## Report to Development Permit Panel

**To:** Development Permit Panel  
**From:** Cecilia Achiam  
Acting Director of Development  
**Date:** November 16, 2007  
**File:** DP 07-363023  
**Re:** Application by Matthew Cheng Architect Inc. for a Development Permit at 9628 Ferndale Road (formerly 9460 and 9628 Ferndale Road)

**1. Development Permit 07-363023 - 47 unit Townhouse**

PLAN #1  
DP 07300003

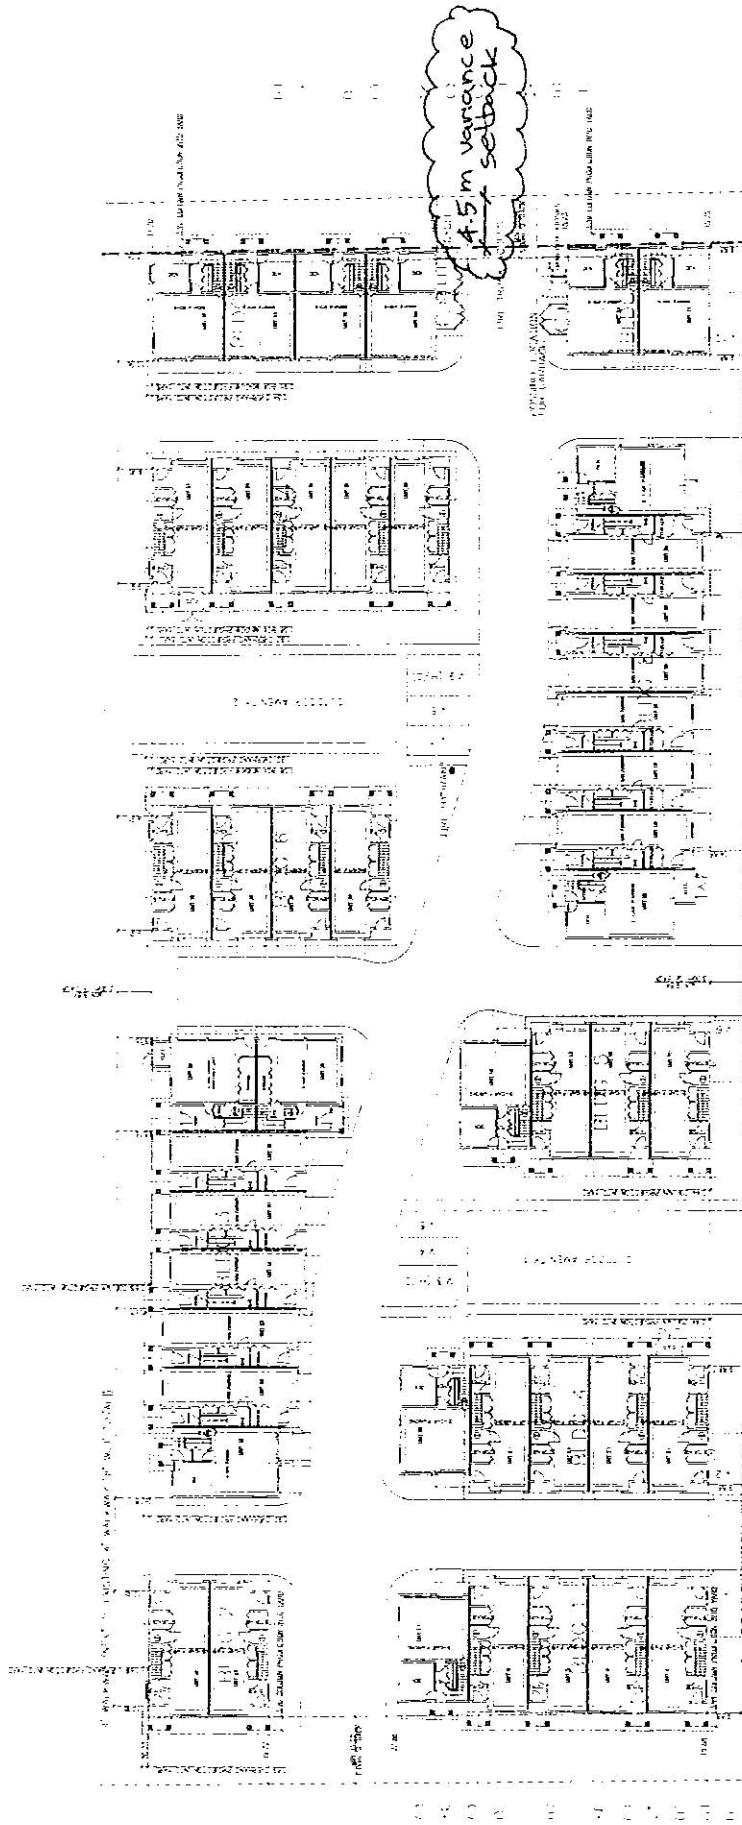
4.5m variance setback

PLAN #3A

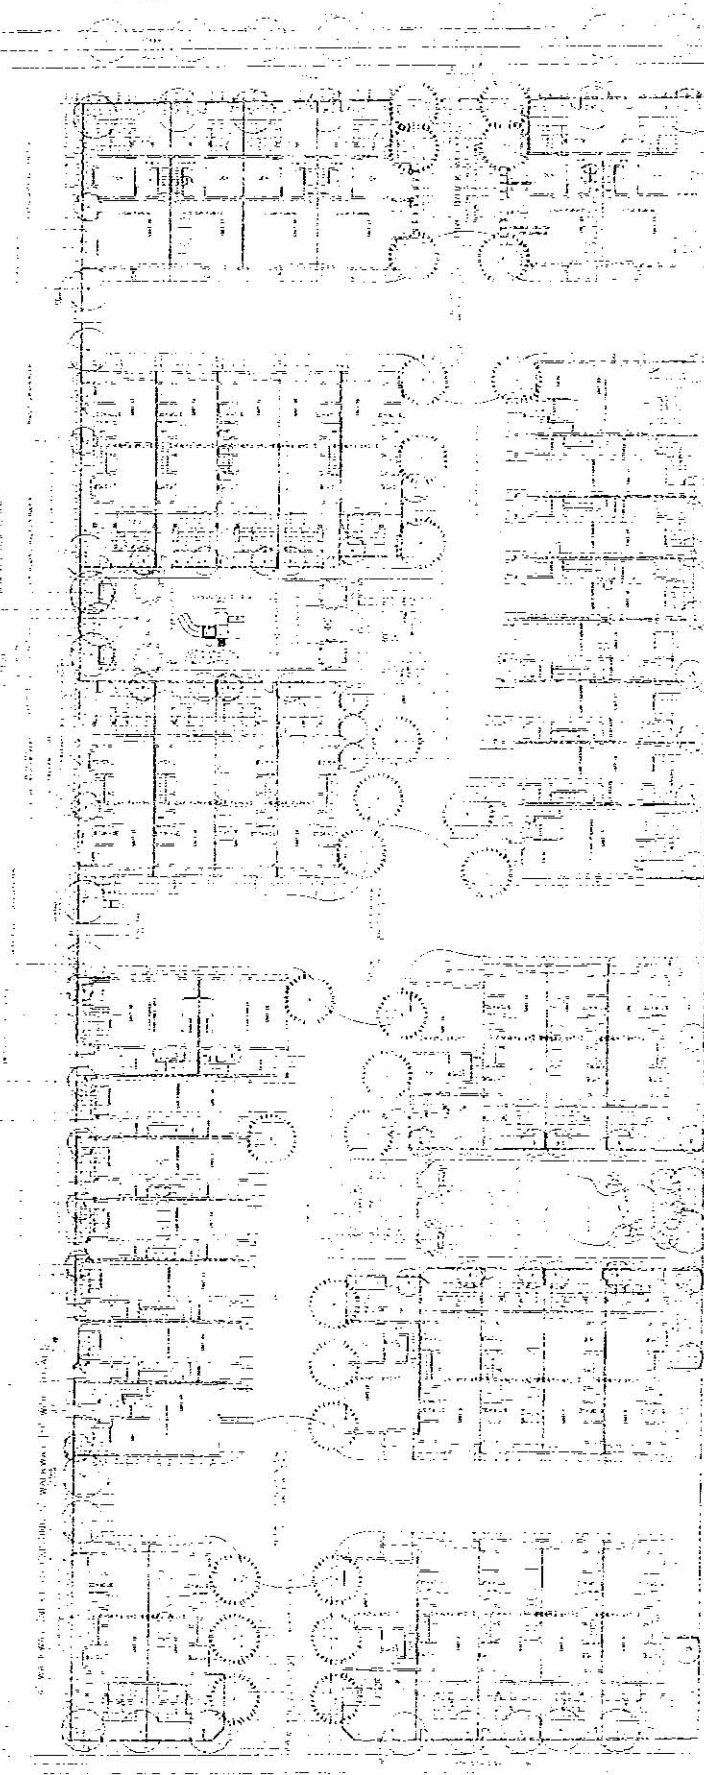
- The Ferndale Road and Hemlock Drive streetscapes are animated with pedestrian-oriented entry gates and front doors at street level, and dens at grade facing Hemlock Drive (**Plans #3a and #4**);

- Headlight glare into adjacent multi-family lots is mitigated to the east by new trees, 1.2 m height picket fencing, and the additional separation of the Greenway; and to the west,

alignment of the road ends with the adjacent road ends and 1.8 m height solid wood privacy fencing (**Plan #3a**);

to new trees, the landscape design includes shrubs, ground cover, vines, perennials, annuals and lawn planting (**Plan #3a**);

PLAN #8  
DP 07363023

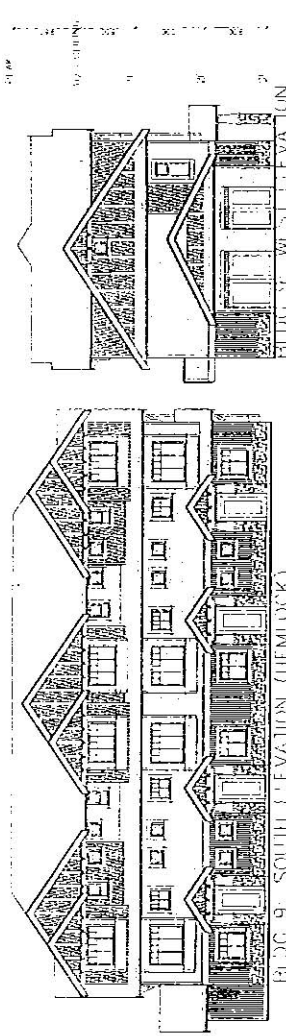
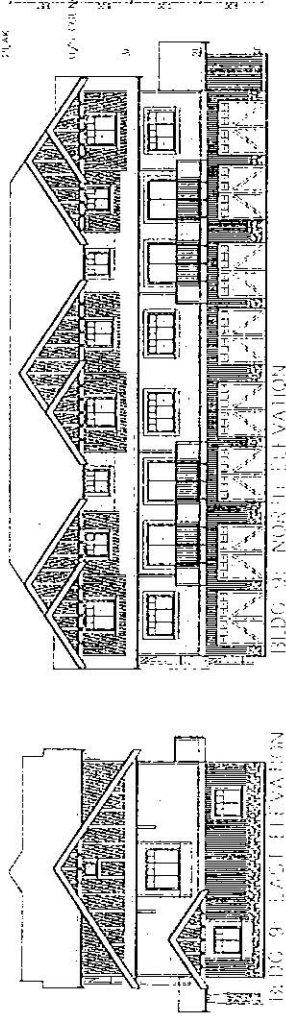
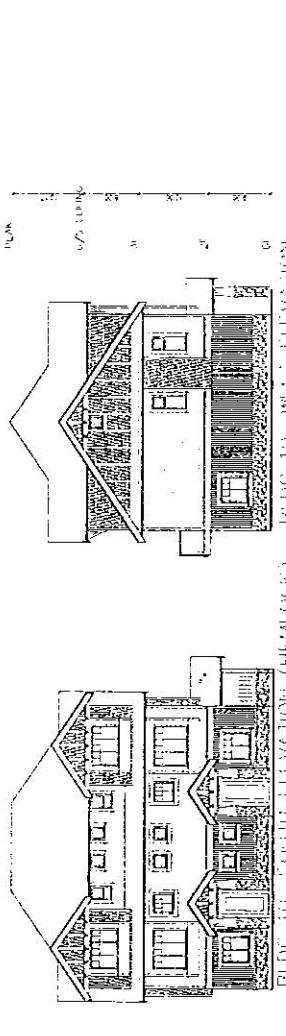
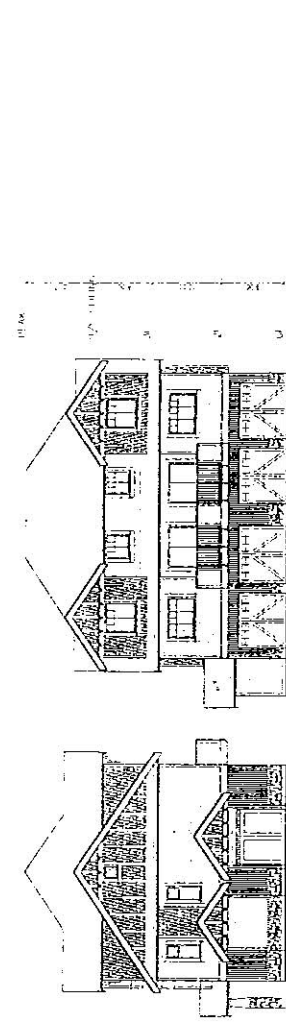
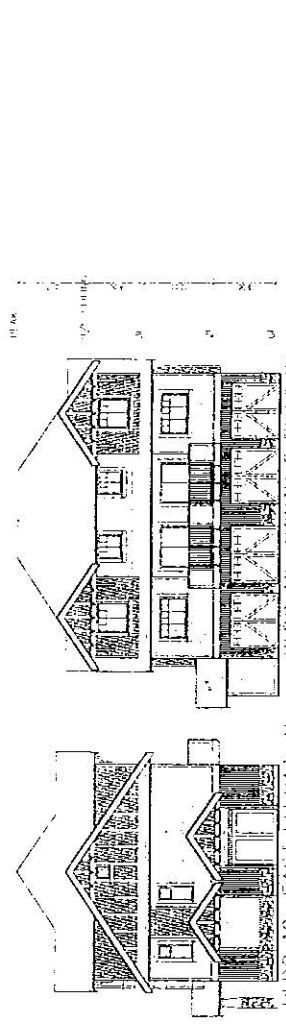
- 1) Reduce the minimum public road setback from Hemlock Drive from 5 m to 4.5 m.

*(Staff supports the proposed variance as the proposal meets the intent of the McLennan North Sub-Area for a distinctive, unifying urban character. Variances to the setbacks are proposed at Hemlock Drive for Buildings 9 and 10. These variances are required to provide additional space for public amenity and visitor parking at the centre of the project. The street design for frontage improvements with this application for Hemlock Drive includes a wide landscaped boulevard at the property line, inside the sidewalk, in addition to the typical boulevard outside the sidewalk at the curb, to maintain a generous pedestrian public realm. The adjacent developments to the east and west are set back at 5.0 m and include porches and third storey bays projecting into the setback. The proposed development includes setbacks at the third storey, to moderate the effect of the variance for a reduced setback of up to 0.5 m, and to maintain the articulated streetscape character consistent with the adjacent developments. Staff supports the proposed variance.)*

3. The "Richmond Zoning and Development Bylaw No. 5300" is hereby varied to:
  - a) Reduce the minimum public road setback from Hemlock Drive from 5 m to 4.5 m.
